HILLCREST COMMONS
FINAL ENVIRONMENTAL IMPACT STATEMENT

NYS Route 52
Towns of Carmel and Kent, New York

HILLCREST COMMONS
Final Environmental Impact Statement
Towns of Carmel and Kent, Putnam County, New York

Addendum

Figure 1-3: Revised Building Layout
 Hillcrest Commons
 Towns of Carmel & Kent, Putnam County, New York
 Source: In-Site Engineering

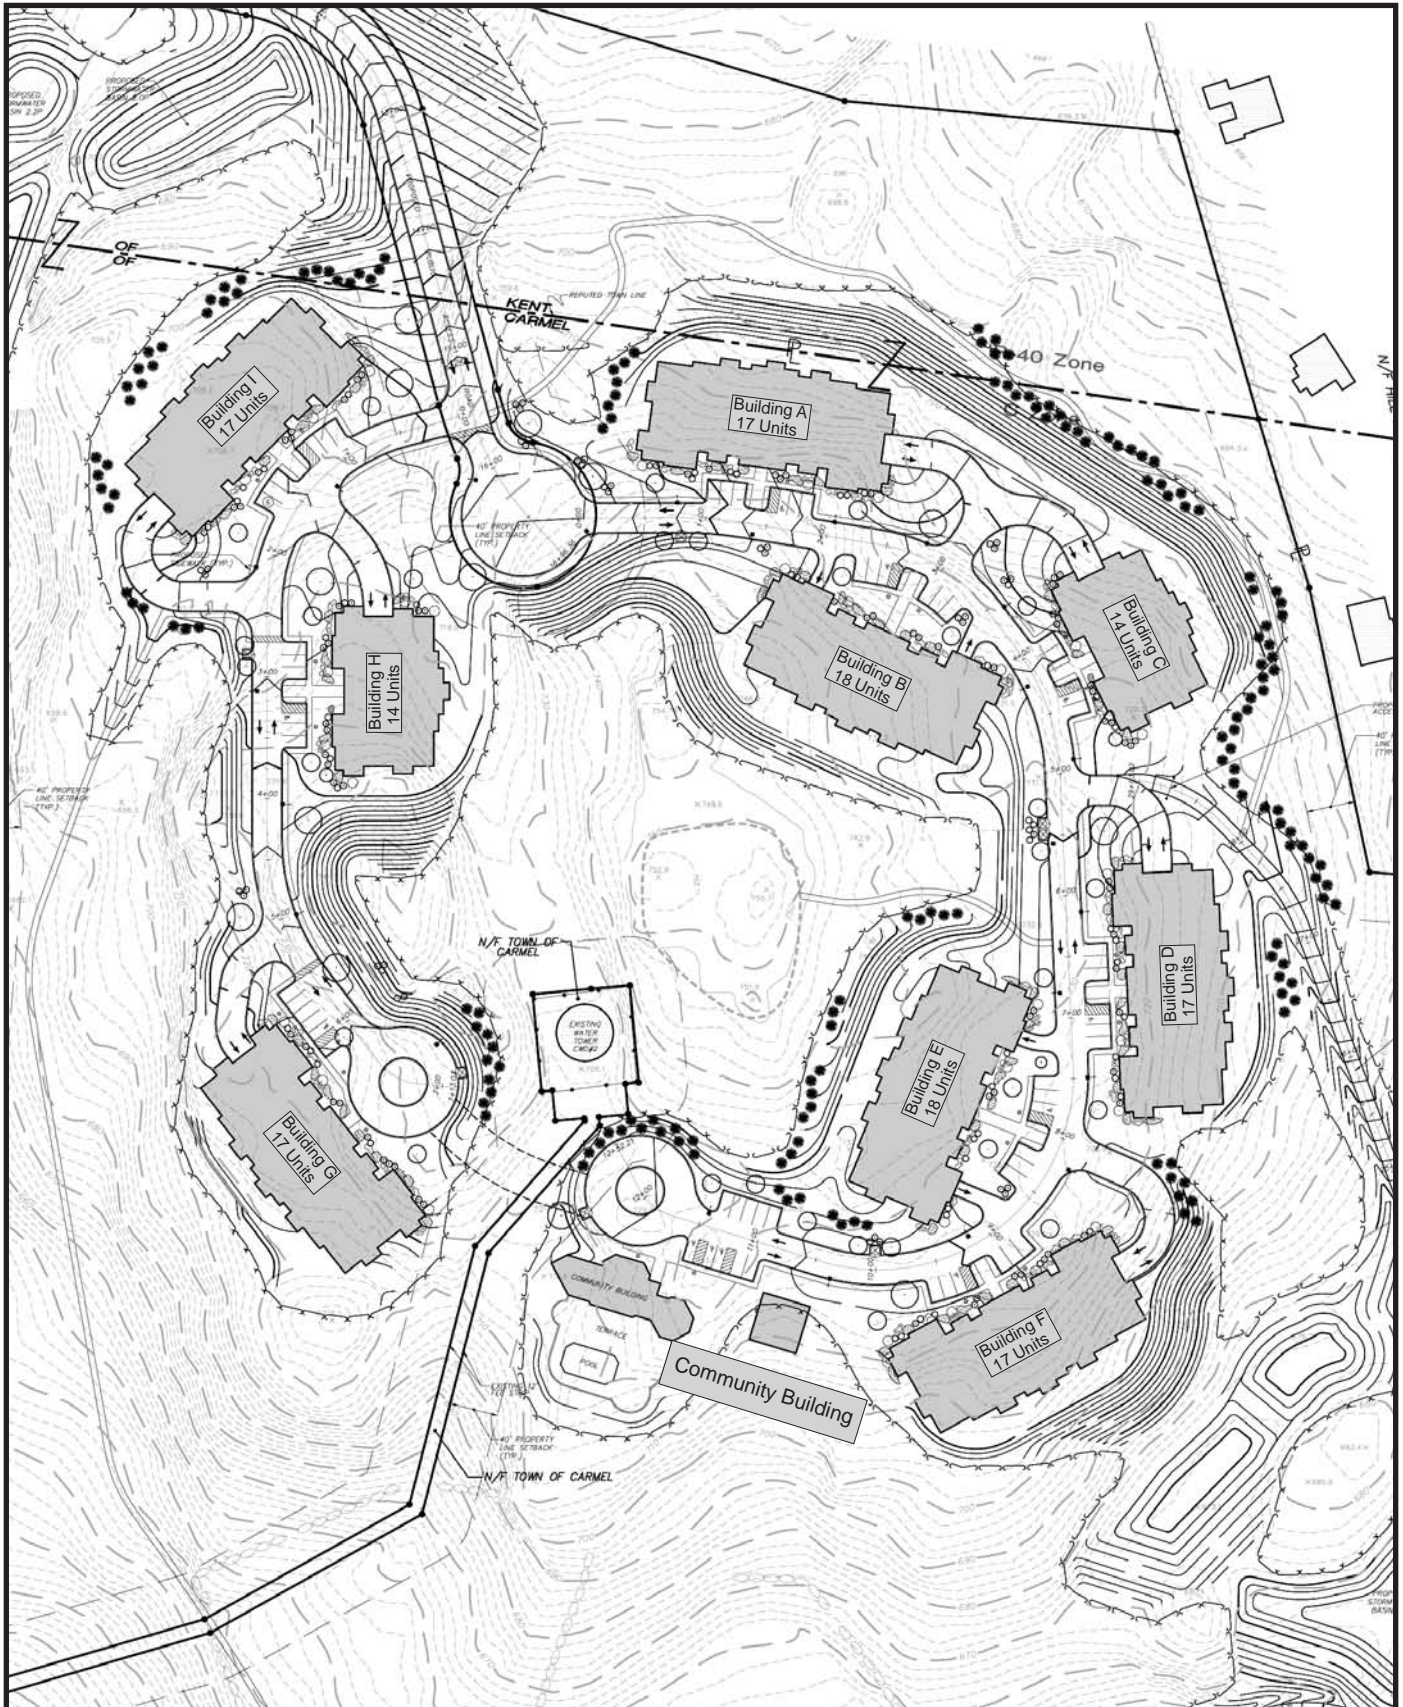
The primary concerns that generated comments to the DEIS included the overall amount of grading and disturbance on the site, the amount of proposed impervious surface, development on steep slopes, and traffic resulting from the project and potential traffic impacts to Route 52. The revised site plan addresses all of the concerns listed above, particularly traffic, since under the former plan, the majority of traffic generated by the project was associated with the proposed office uses.

The revised Site Plan consists of nine multi-family residential buildings located at the end of a cul-de-sac entrance road from Route 52 (see Figure 1-2). The entrance road and cul-de-sac design have not been modified from the original Site Plan. The proposed residential buildings are located on two private driveways that extend to the west and the east of the cul-de-sac. The existing Town of Carmel water tower and the wooded hilltop will separate the two clusters of buildings. Six buildings will be located on the eastern side of the hilltop, with the buildings and driveway located and graded to fit into the sloping hillside. Three buildings will be located on the western side of the hilltop, also positioned parallel to the contours on the slope.

A major difference between the revised layout and the former site plan is that an area at the prominent hilltop will remain undisturbed and the existing tree cover and vegetation located there will also be preserved. This area measures approximately 300 feet by 360 feet, or 2.5 acres at the top of the hill. This preserved green space will be available to project residents for passive recreation. In the Applicant's opinion, this modification will soften the visual changes to the project site, especially from Route 52 and viewpoints west and south of the site.

Parking is now provided under the nine residential buildings. Access to the at grade parking will be from single driveways to the sides of the buildings. The provision of 252 parking spaces under the buildings substantially reduces the area of pavement or impervious surface needed for residential parking. The area of impervious surface has been reduced by 2.1 acres, compared to the former plan. The reduced impervious surface allows two stormwater management facilities to be reduced in size by approximately 25 percent, resulting in less grading and site disturbance, as described below.

Fig 2-1: Road Comparison Profile
 Hillcrest Commons
 Towns of Carmel and Kent
 Putnam County, New York
 Source: Insite Engineering, Surveying &
 Landscape Architecture, P.C.
 Date: 11/05

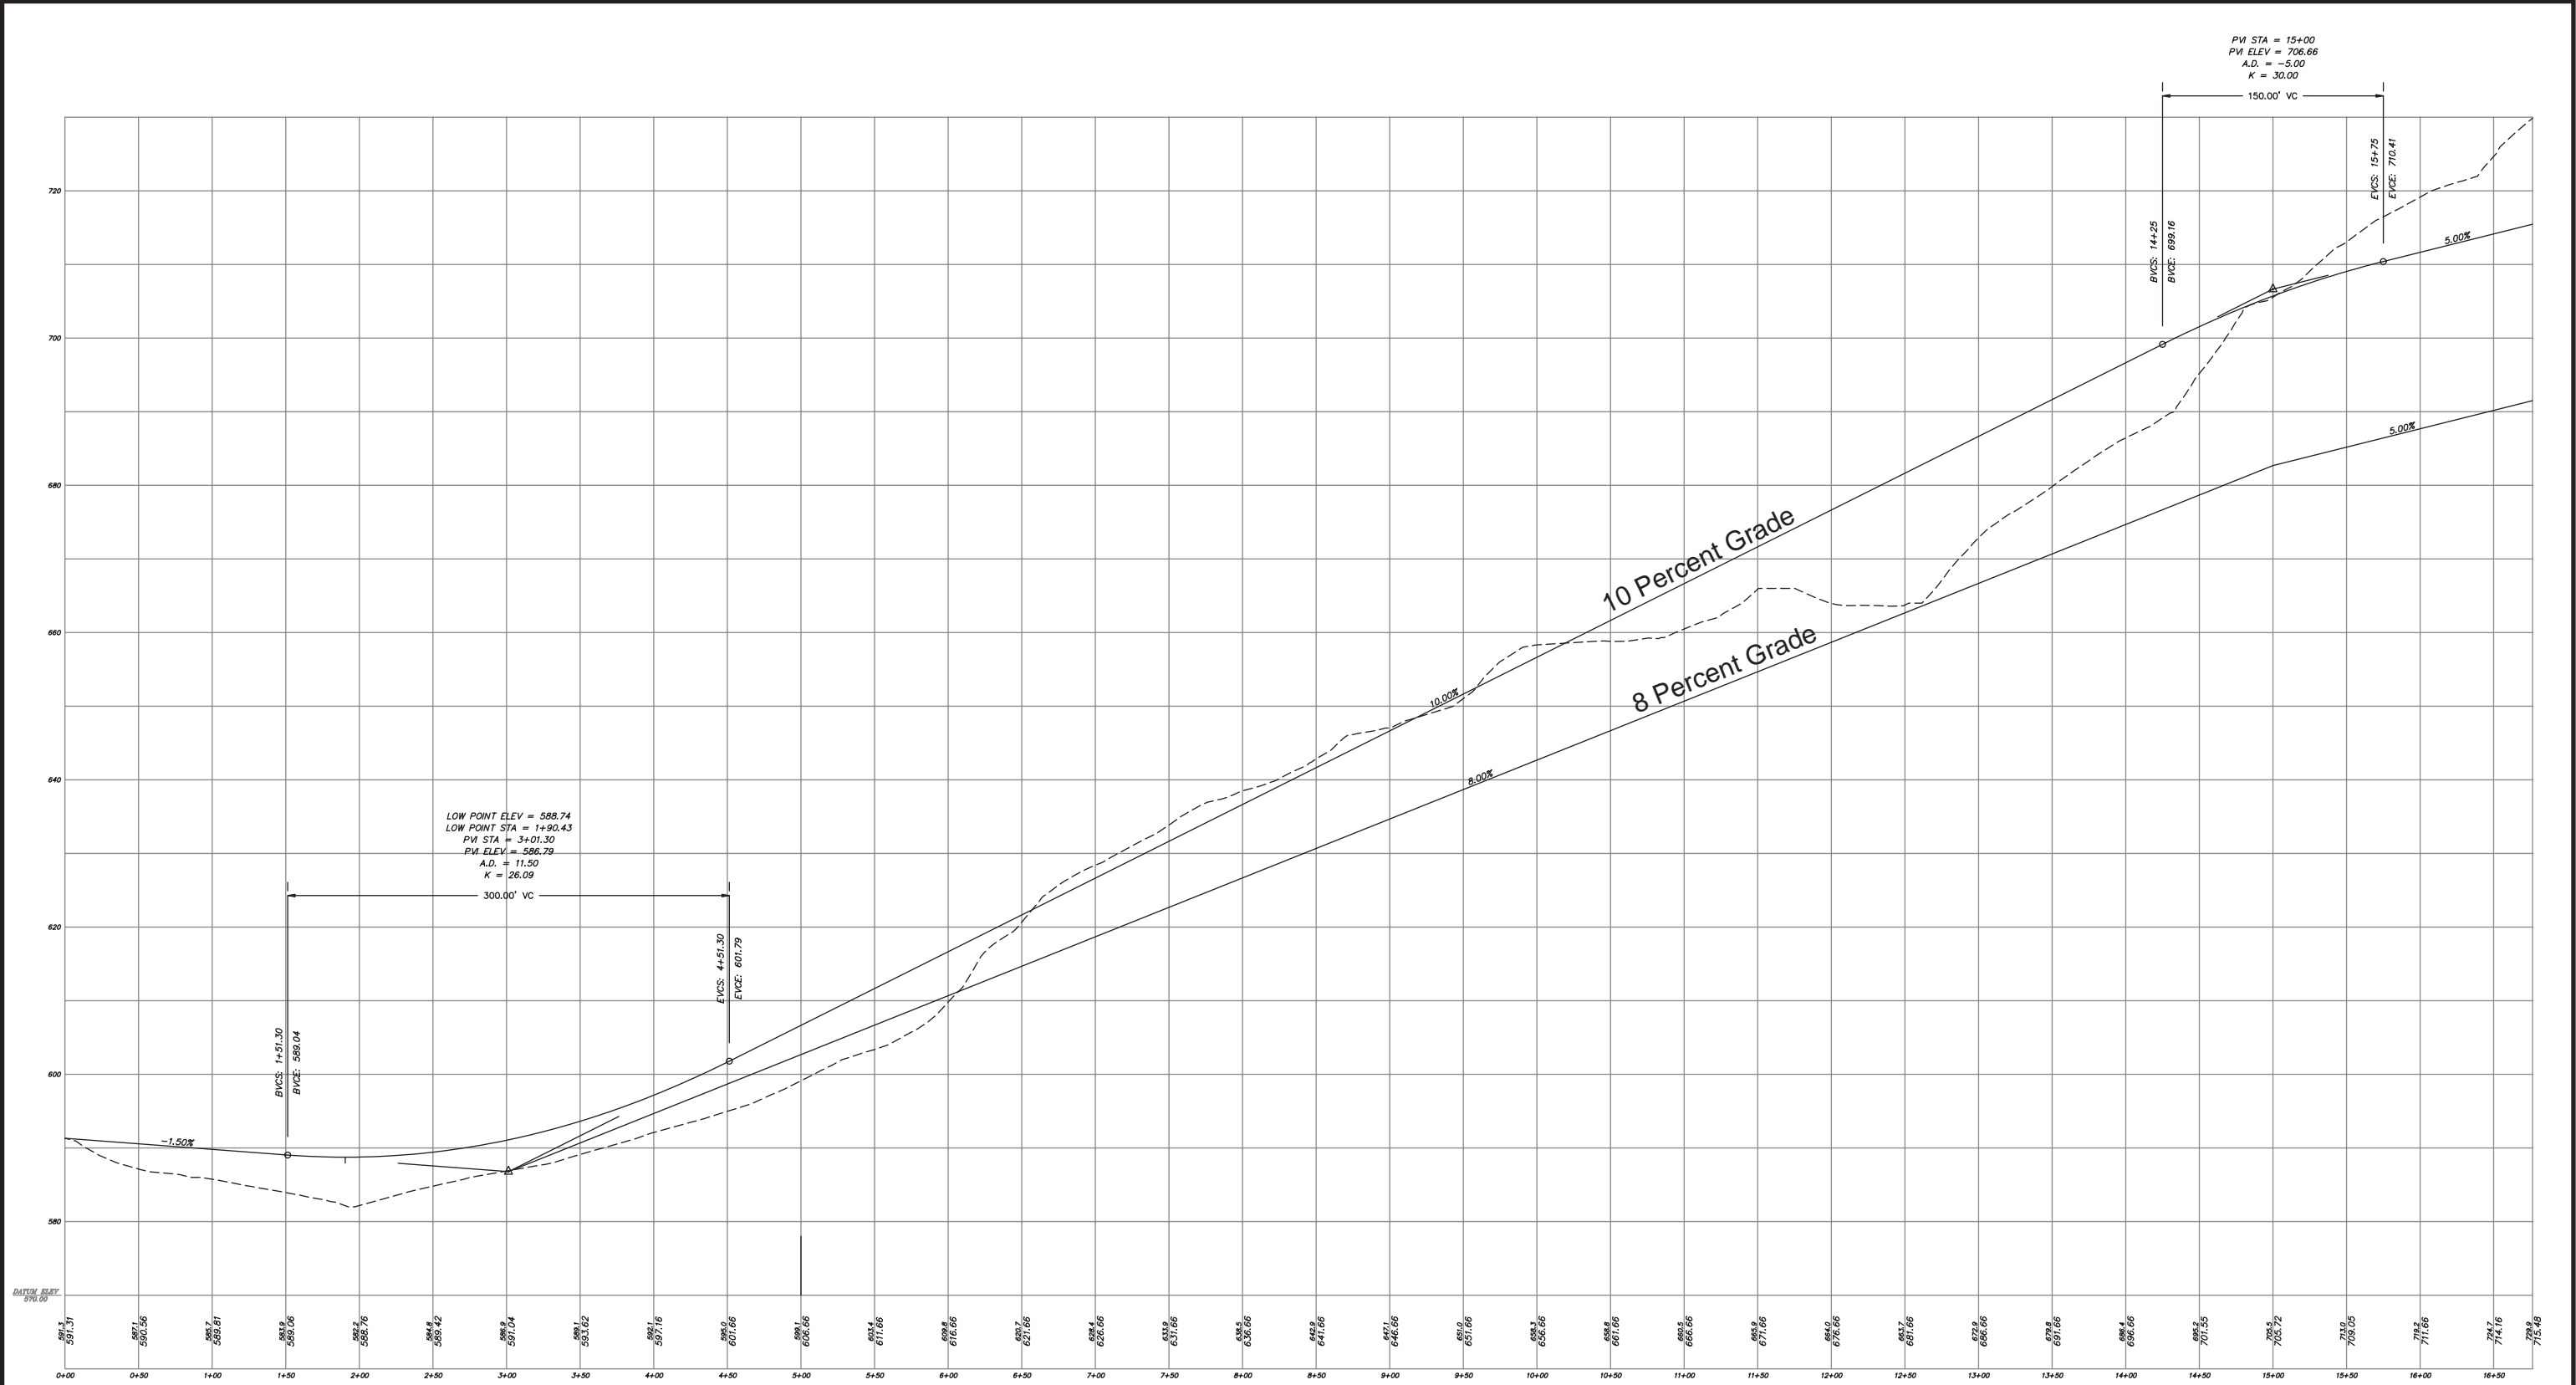
Comment 2-4b (Letter #2, Memorandum from Rohde, Soyka, and Andrews, July 28, 2005):

b.) The applicant should submit a plan showing the road at the maximum permitted slope of 8% so that the impacts of a road at this slope can be evaluated. The applicant should submit a summary of the advantages and disadvantages of each proposal for consideration by the Planning Board.

Response 2-4b: *The attached road profile, Figure 2-1 Road Profile Comparison, illustrates the differences between an 8% centerline grade and the proposed 10% centerline grade. The overwhelming advantage to allowing a centerline grade of 10% is reducing the amount of required grading and disturbance. As shown in the attached figure, a 10% centerline grade is advantageous for the following reasons:*

As shown in the attached road profile (Figure 2-1), the required grading needed to achieve an 8% road grade compared to a 10% grade is significant. Reducing overall disturbance and unnecessary excavation, the Applicant notes, reduces a number of grading related impacts including: tree removal, potential soil erosion, blasting, material export from the site and the number of required truck trips during construction. Reducing the number of construction vehicles on local roads lessens the overall impact to traffic during construction.

Figure 8-1: Potential Route 52 Turning Lane
 Hillcrest Commons
 Towns of Carmel and Kent
 Putnam County, New York
 Source: Insite Engineering, Surveying &
 Landscape Architecture, P.C.
 Date: 03/06

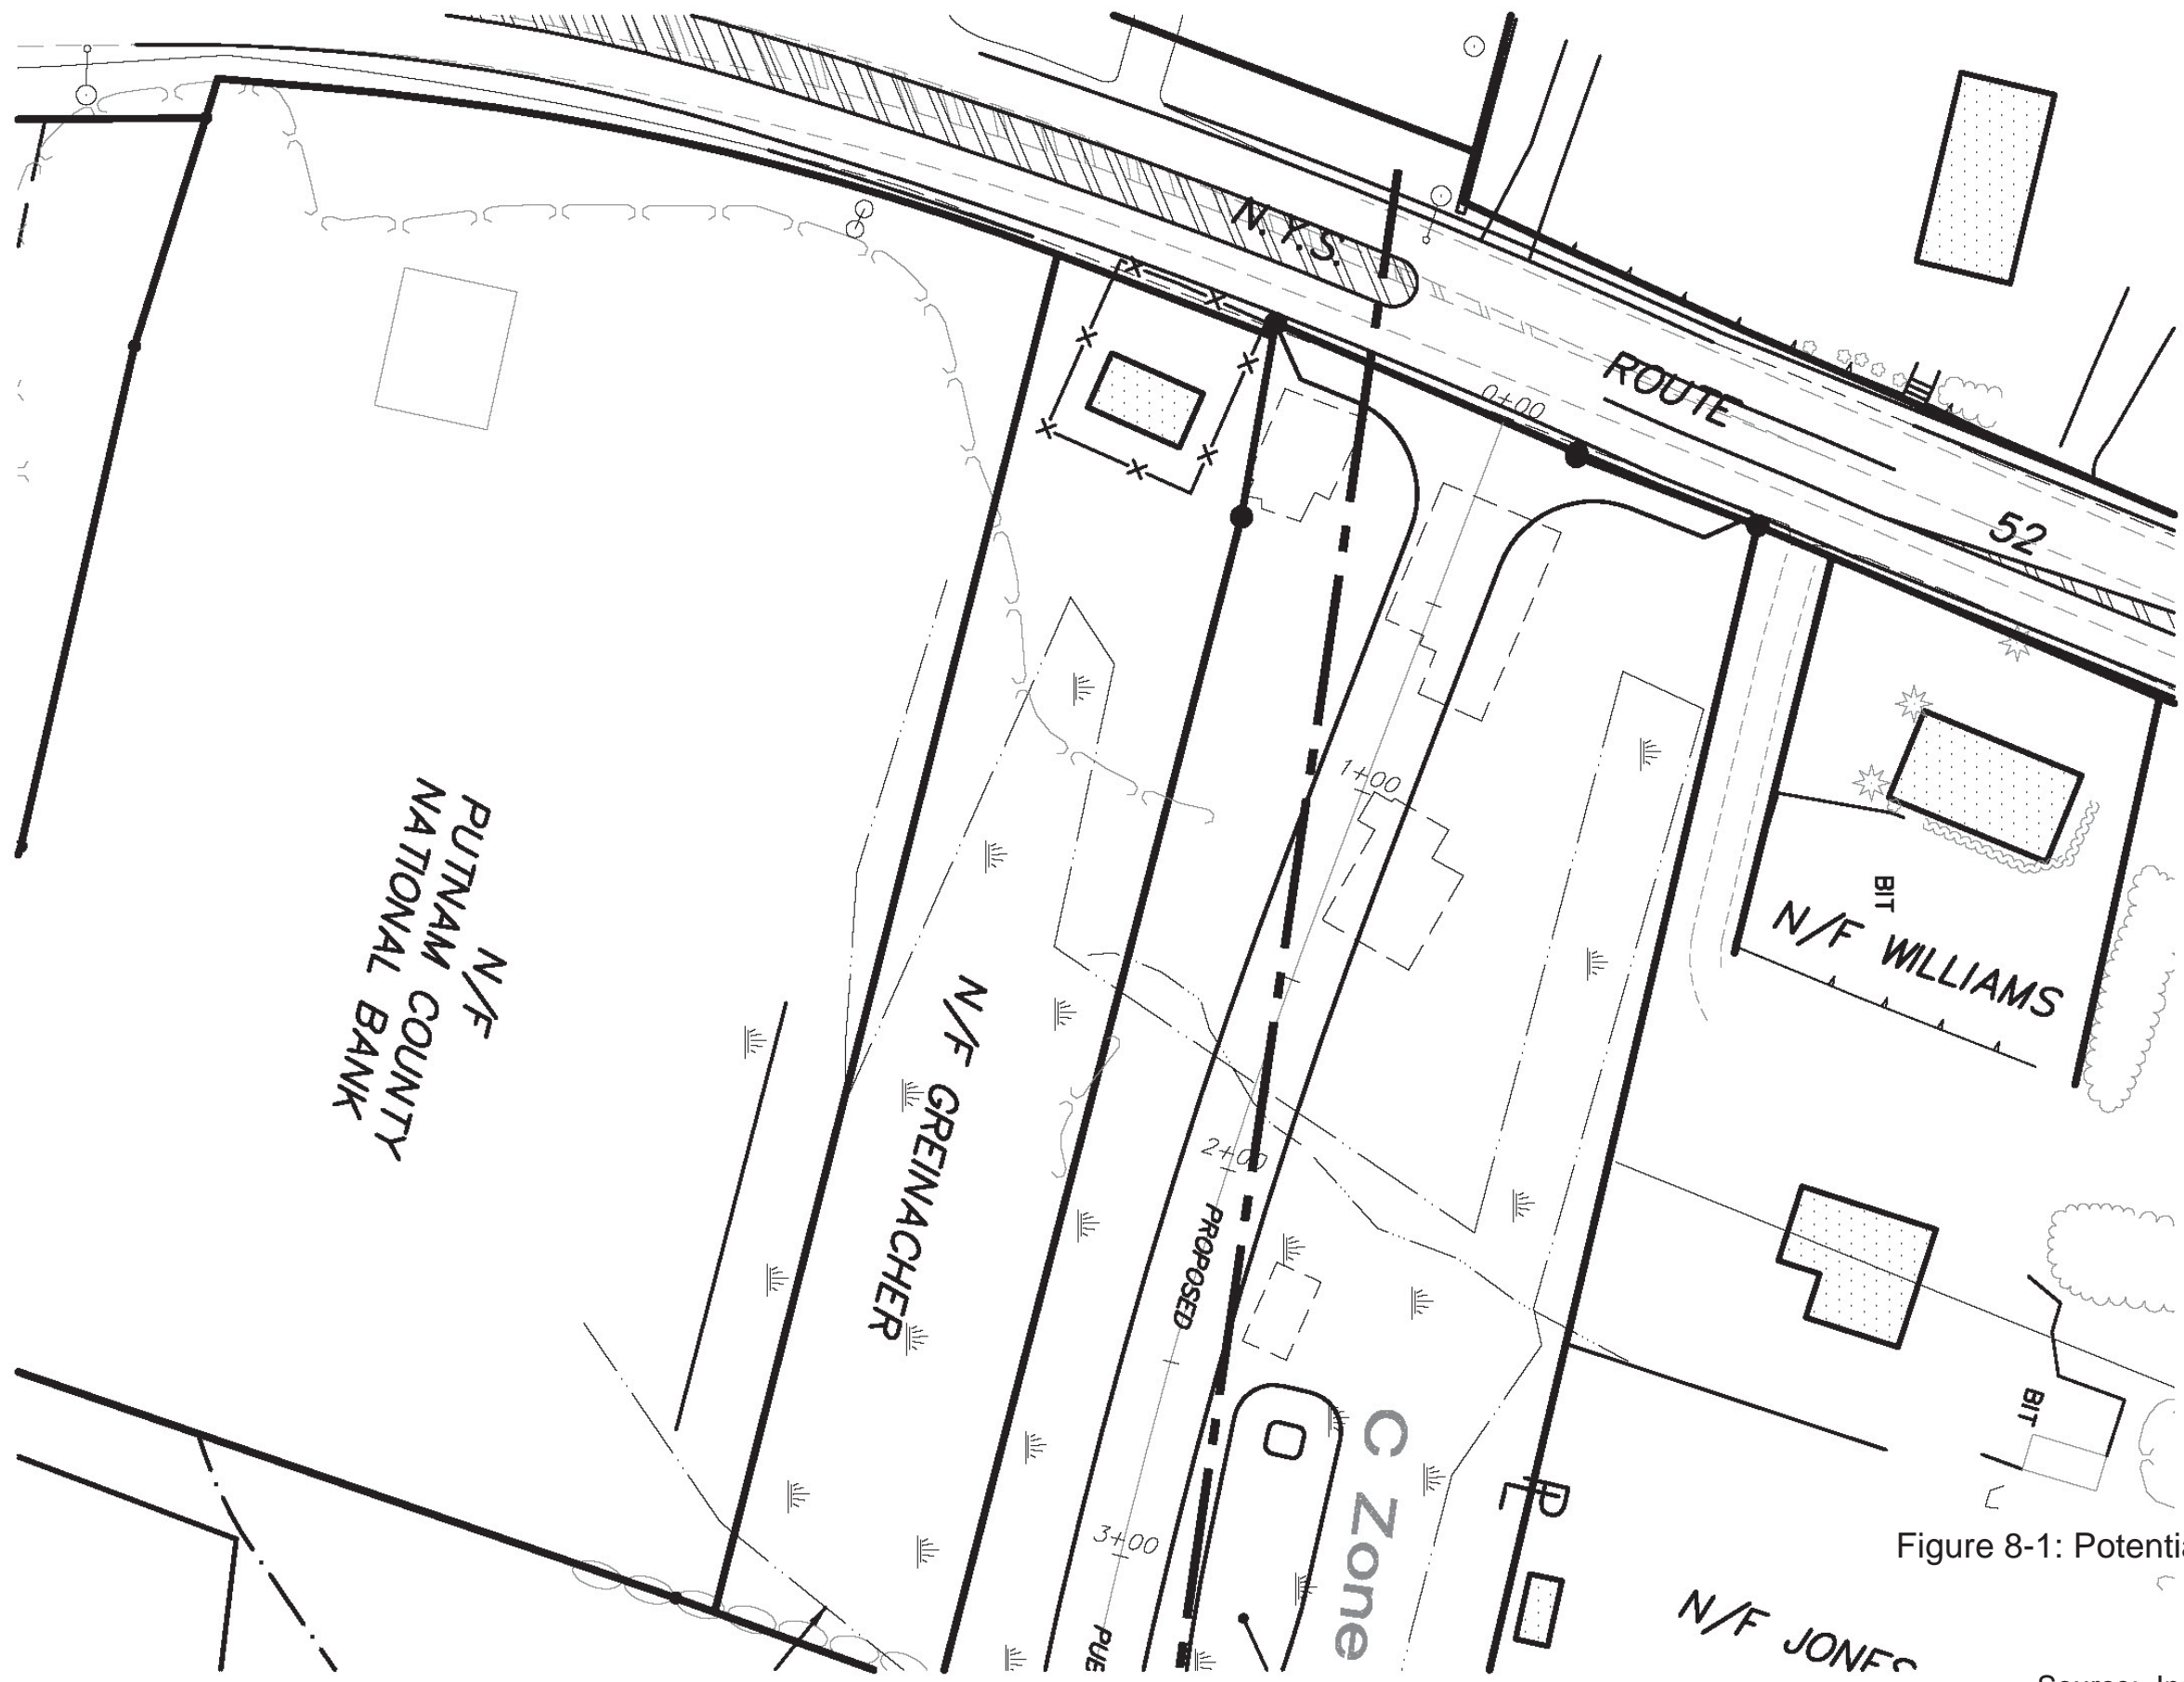
Comment 8-52 (Letter #12, Letter from Adler consulting, August 19, 2005): Furthermore, the Site Plans do not show a dedicated southbound left-turn lane on NY Route 52 to accommodate vehicles turning left into the Site without obstructing southbound through-moving vehicles. A comparison of the DEIS Build traffic volumes with the information provided in Exhibit 9-75 of the American Association of State Highway and Transportation Officials' (AASHTO) *Policy on the Geometric Design of Highways and Streets, 2004* indicates that a left turn lane should be considered on NY Route 52 at this location. The construction of such a lane may further impact sight distances. The FEIS should discuss the need for and feasibility of constructing a left-turn lane and whether it will have any impact on intersection sight distances.
